SUBJECT: NEW ORCHARD FARM ELEMENTARY SCHOOL  
ORCHARD FARM R-V SCHOOL DISTRICT  
ST. CHARLES, MISSOURI  
PROJECT # 23-09B

Enclosed please find one (1) electronic .pdf copy of Addendum No. 2, dated August 1, 2024, for the above-named project.

ORCHARD FARM R-V SCHOOL DISTRICT  
NEW ELEMENTARY SCHOOL  
ST. CHARLES, MISSOURI

2  
M3.2  
**RTU-4 AND STORM SHELTER PENETRATIONS**  
SCALE: 1/4" = 1'-0"

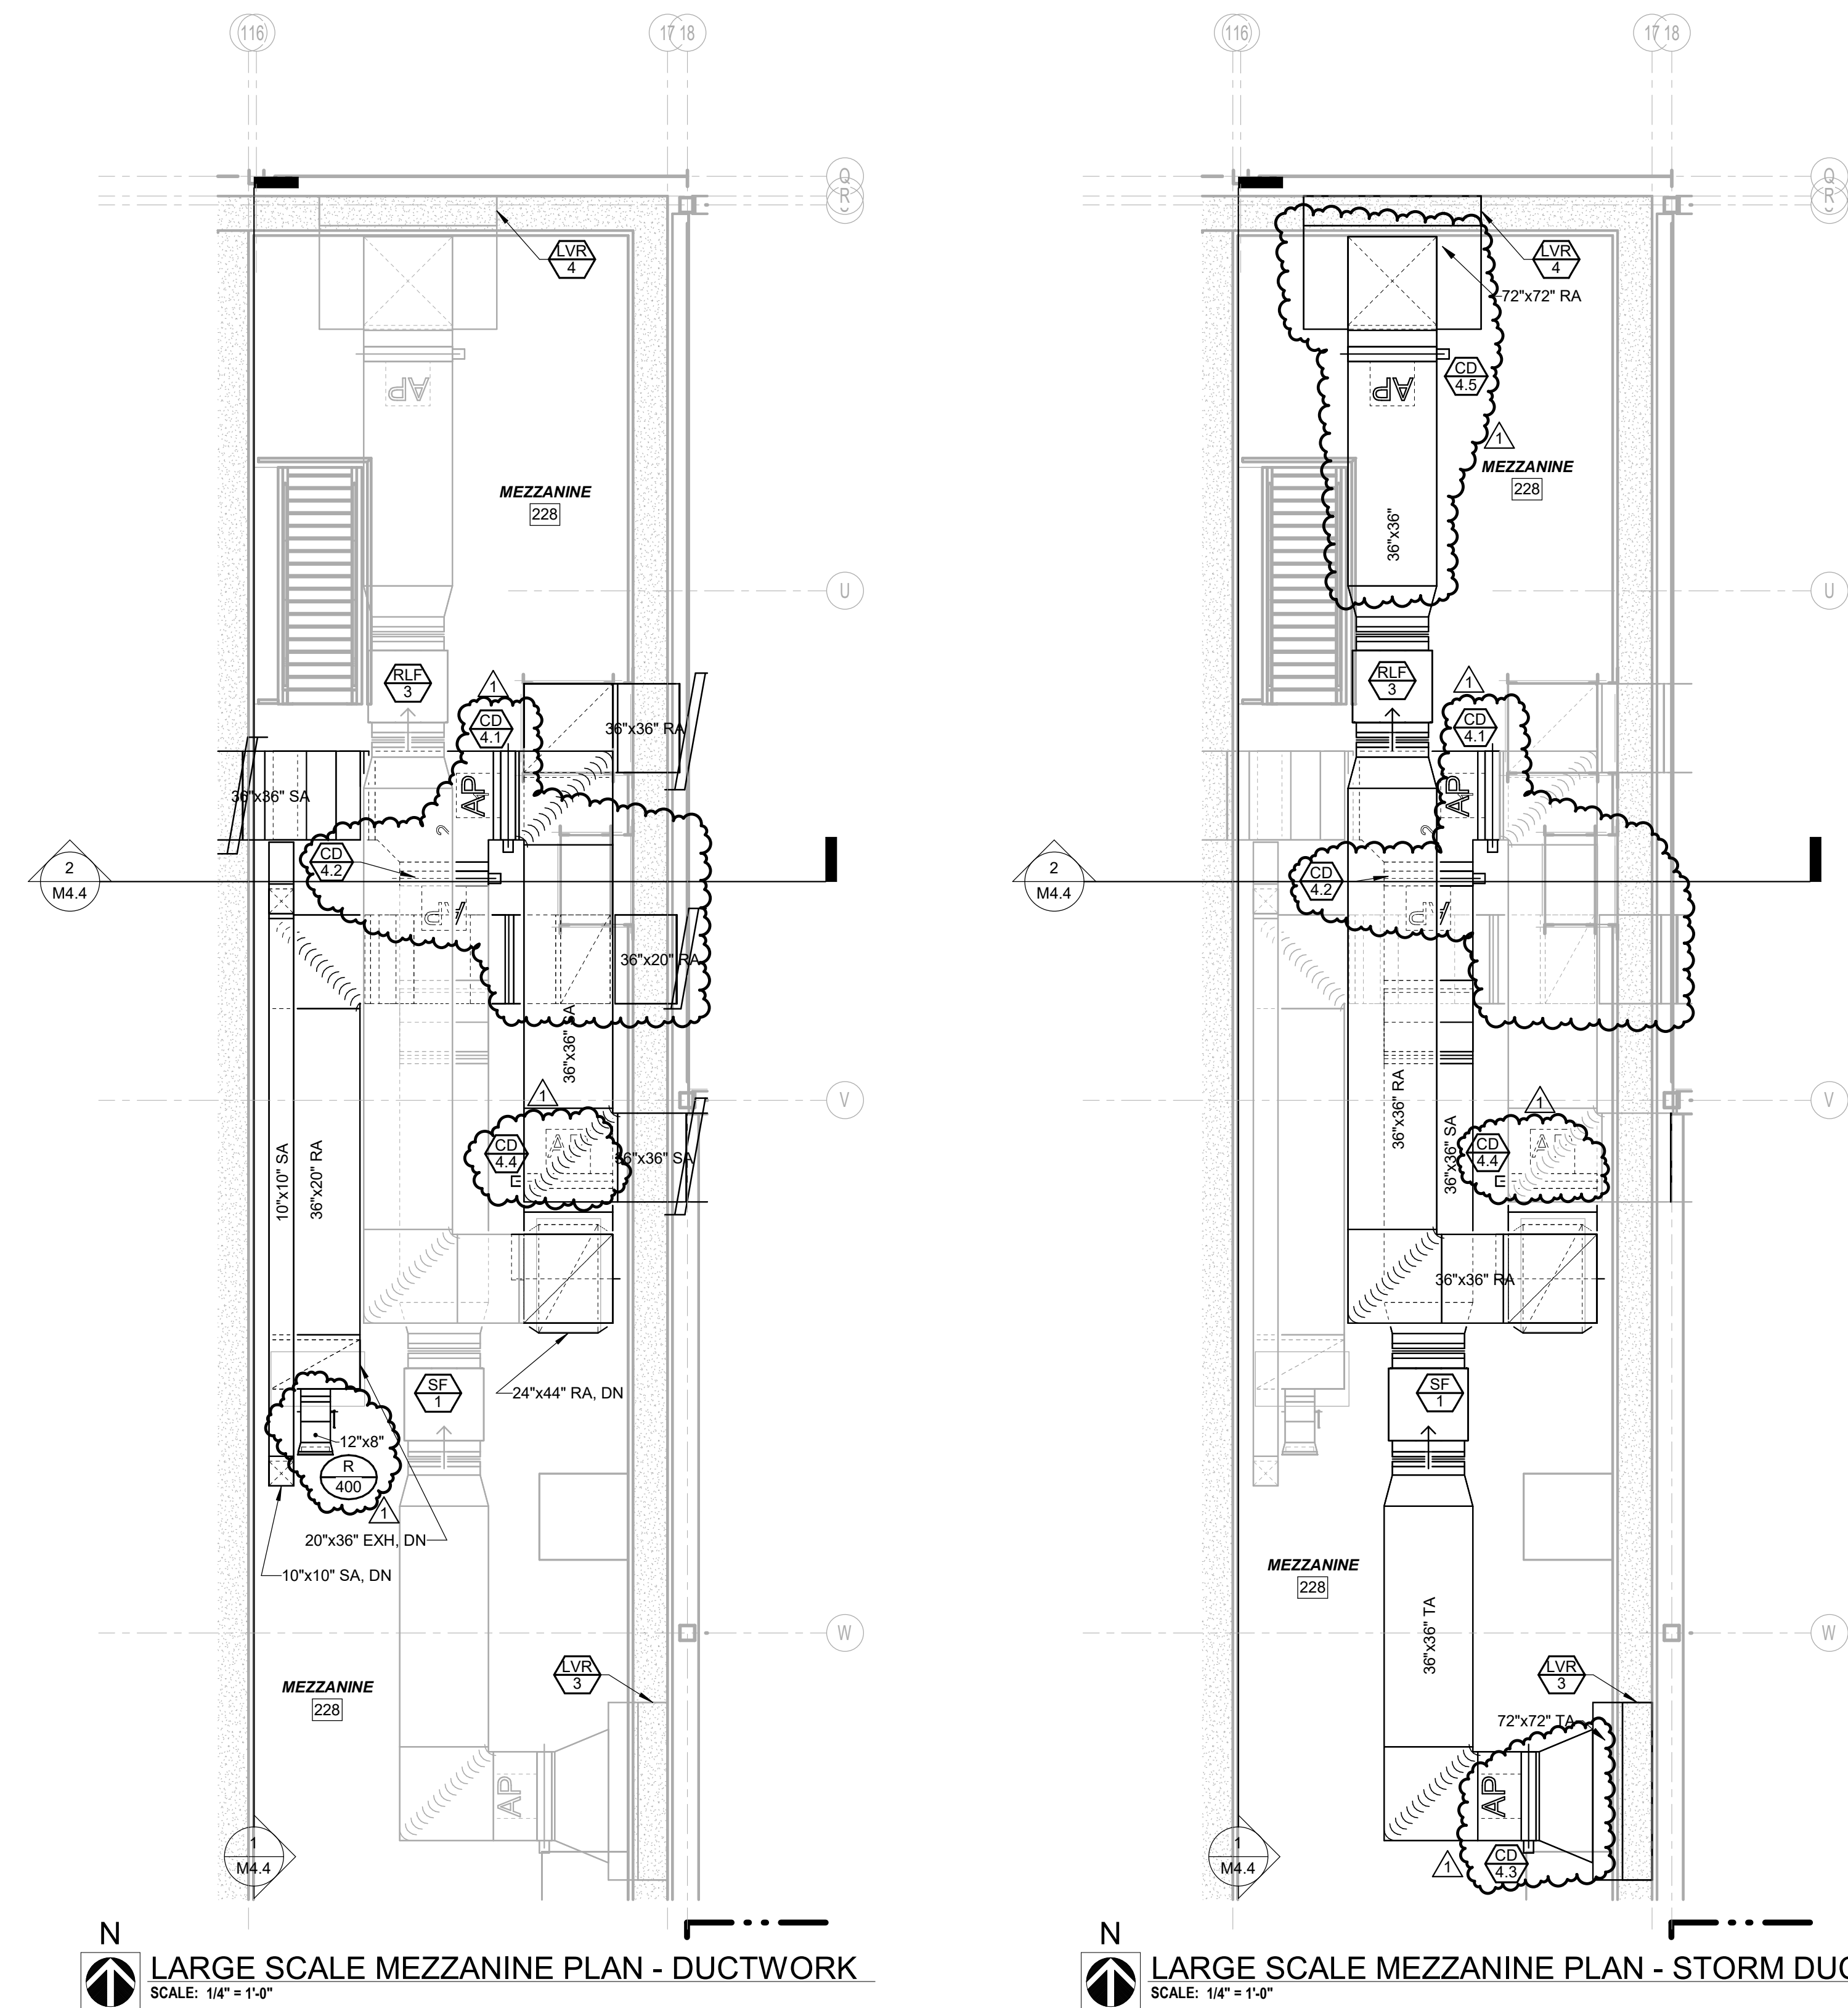
ITEM NO. 19 – MECHANICAL DRAWING SHEET M3.2

- A. **“REVISE”** Storm Duct in Mezzanine.
- B. **“REVISE”** Note 2 to be for 50 cfm.
- C. **“REVISE”** Supply air duct sizes to Mech Office 303 and DZ Office 321
- D. **“REVISE”** RTU-4 Return air duct.

**M4.4**  
SD: 44

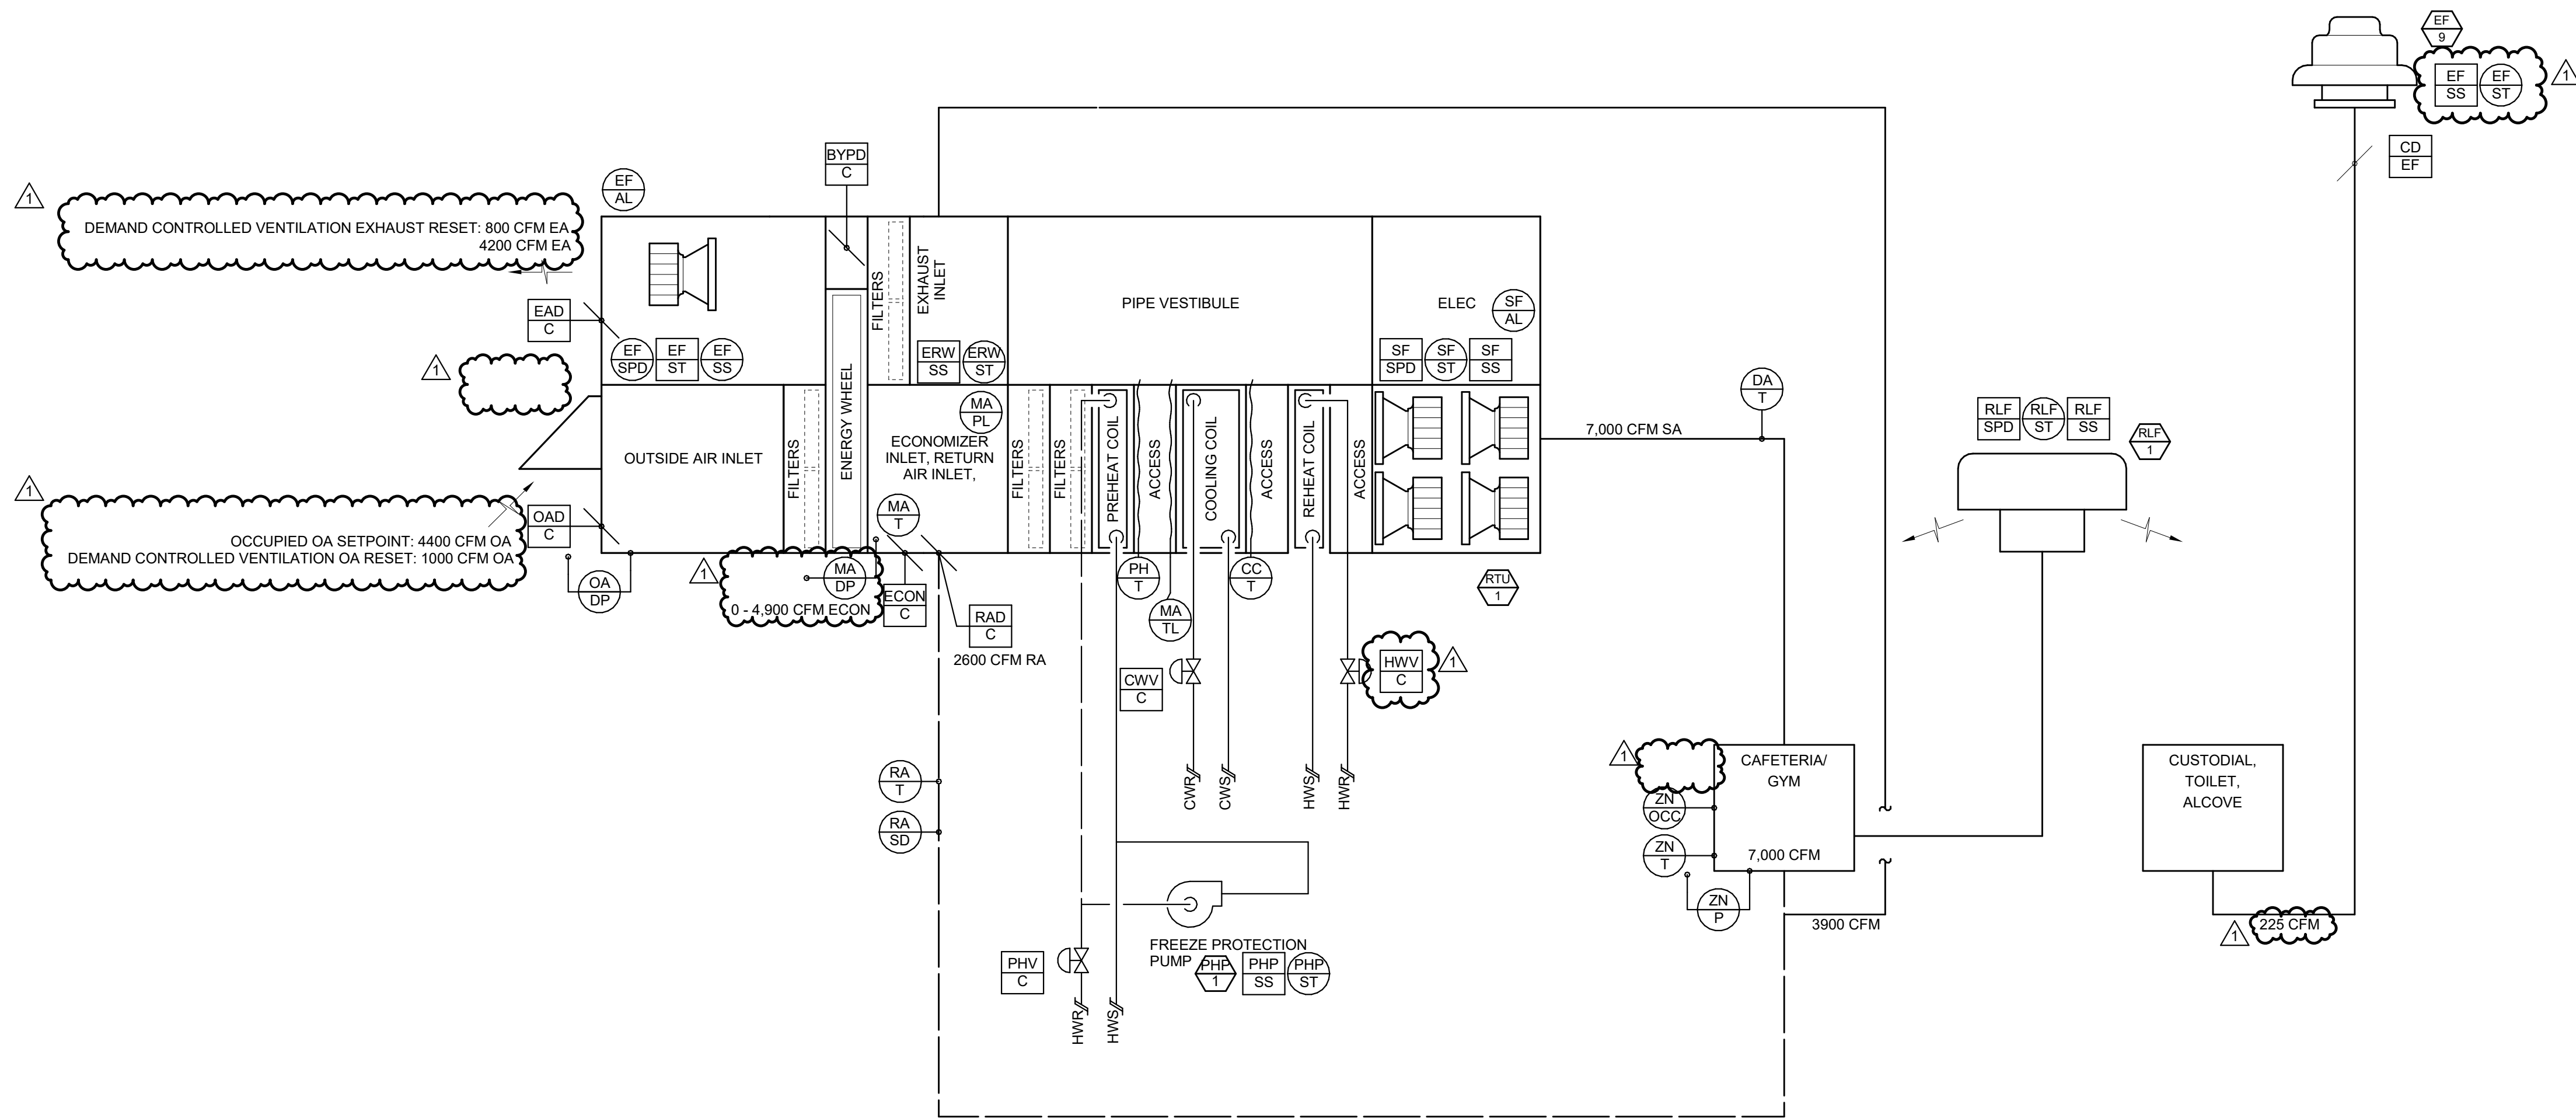
ITEM NO. 26 – MECHANICAL DRAWING SHEET M4.4

- B. **“REVISE”** RTU-4 Duct system layout. See sheet for additional detail.

P1.2

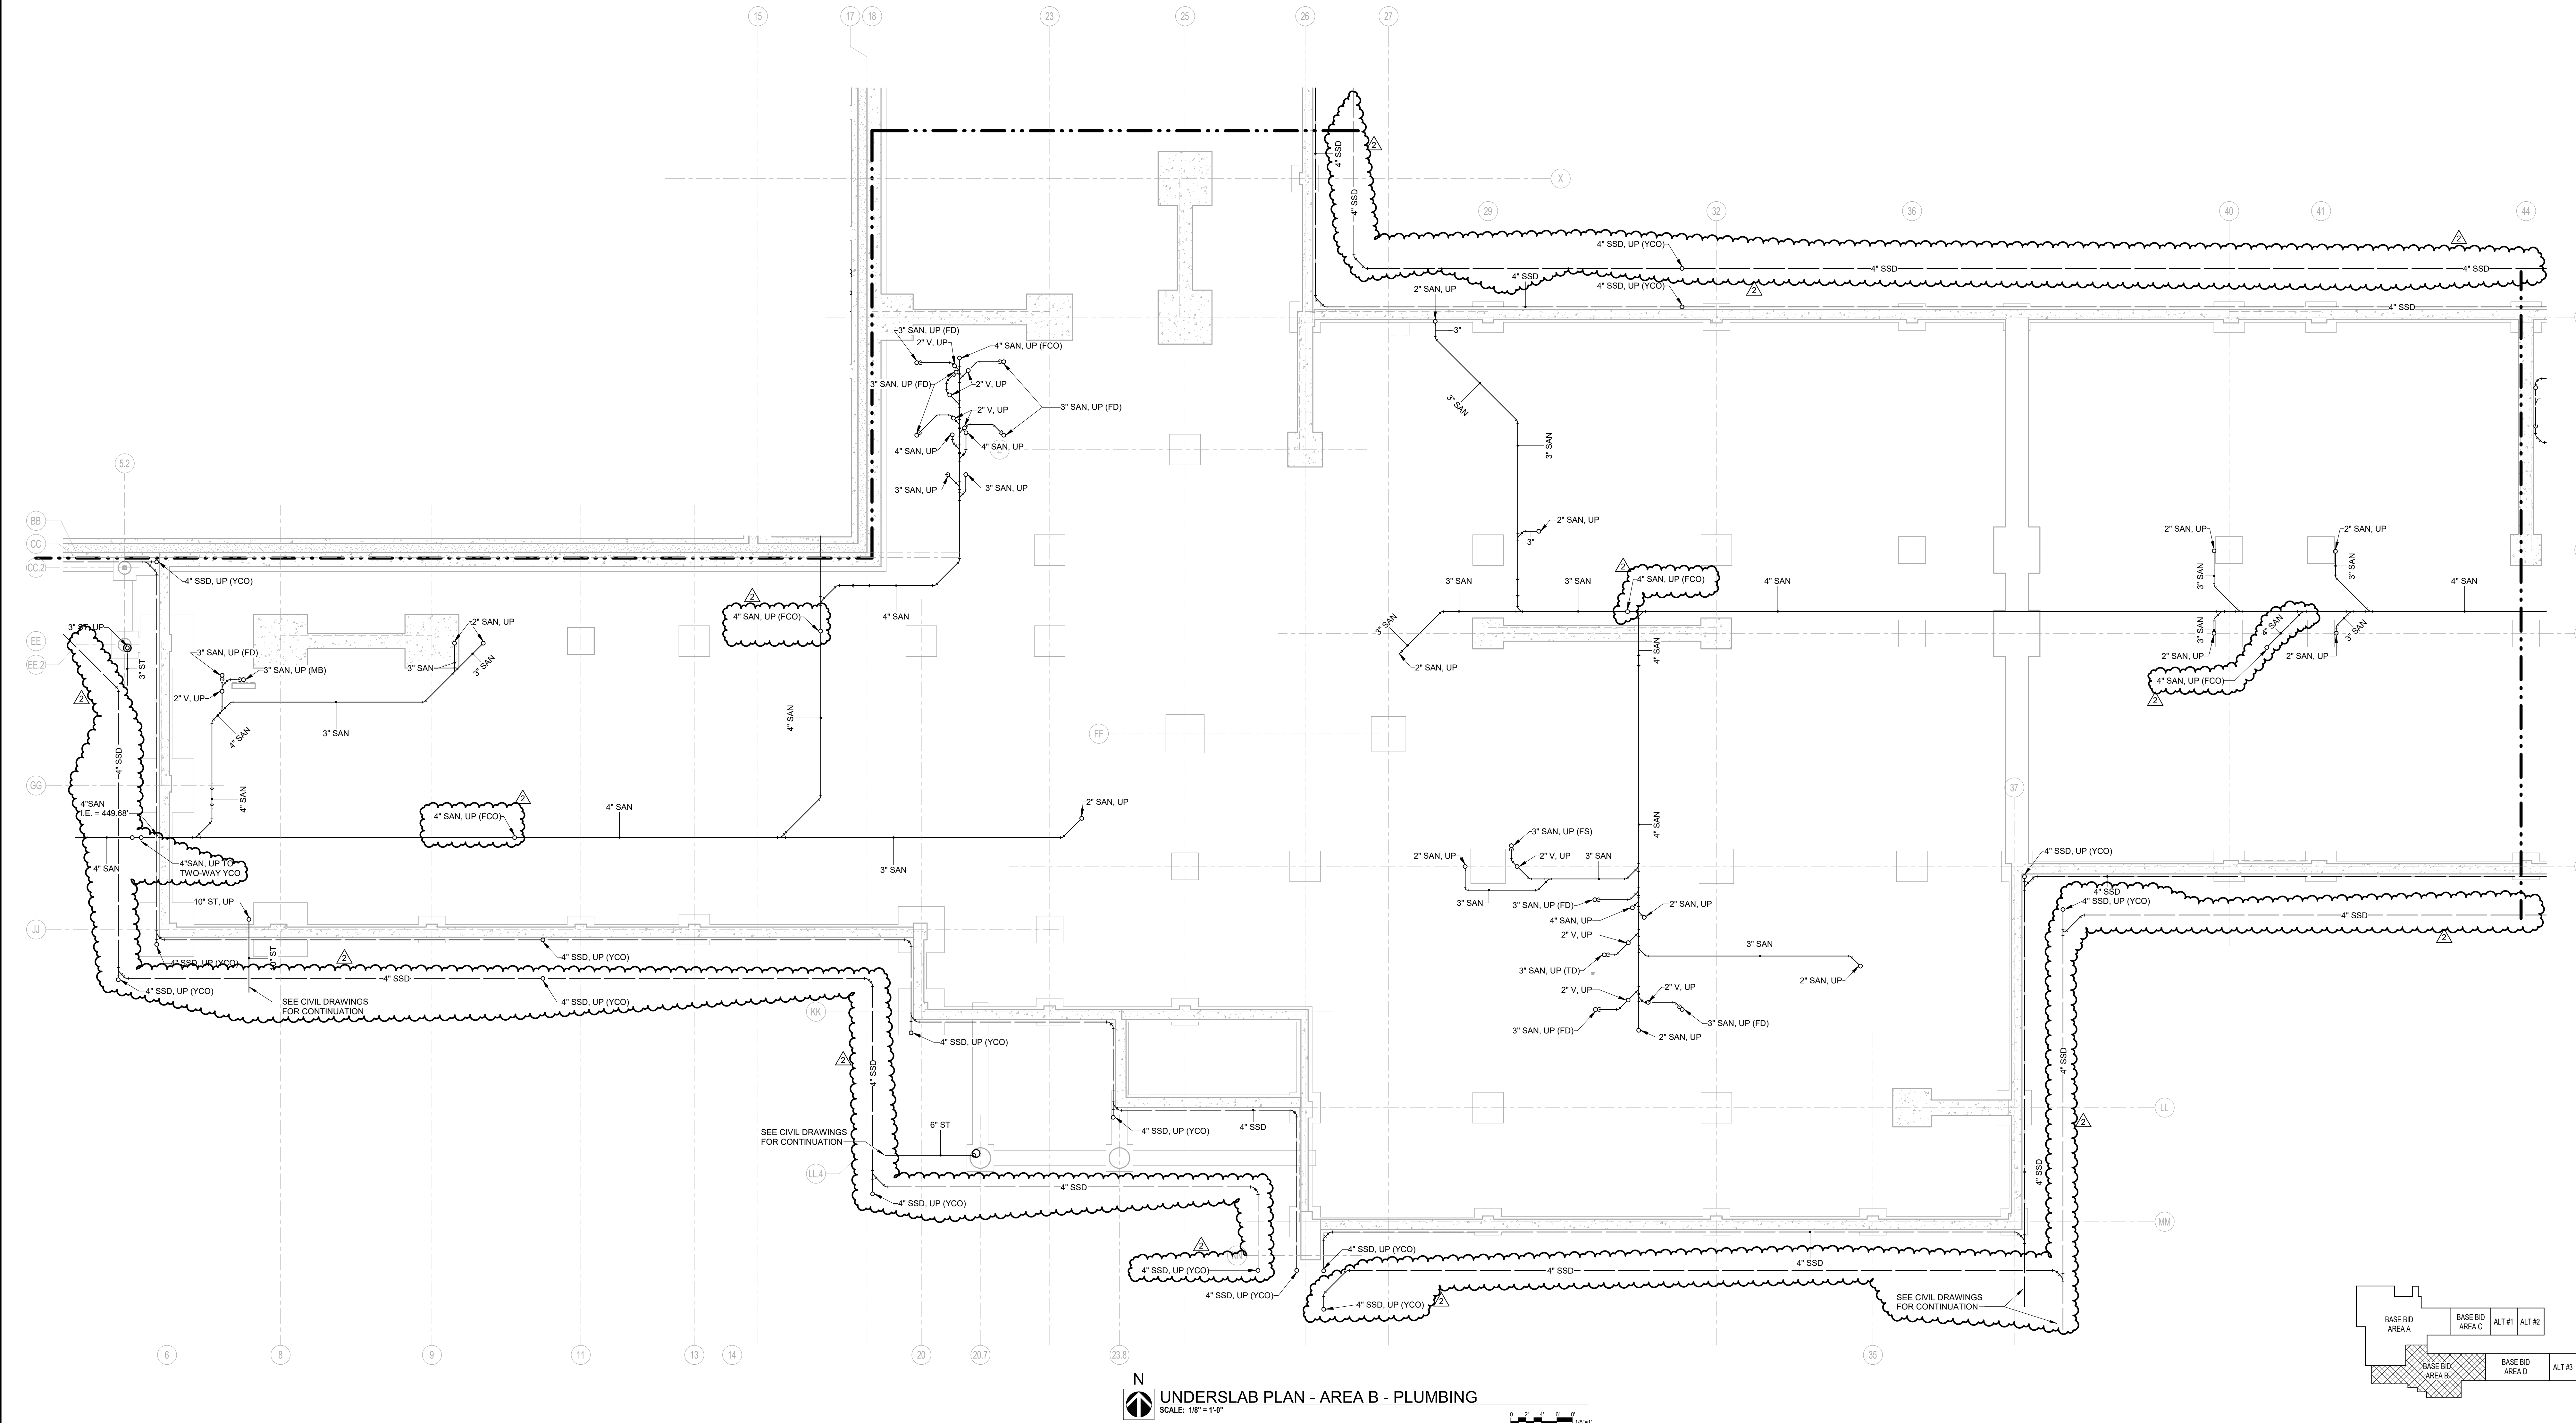
ITEM NO. 44 – MECHANICAL DRAWING SHEET P1.2

- A. **“ADD”** Secondary perimeter subsoil drainage.
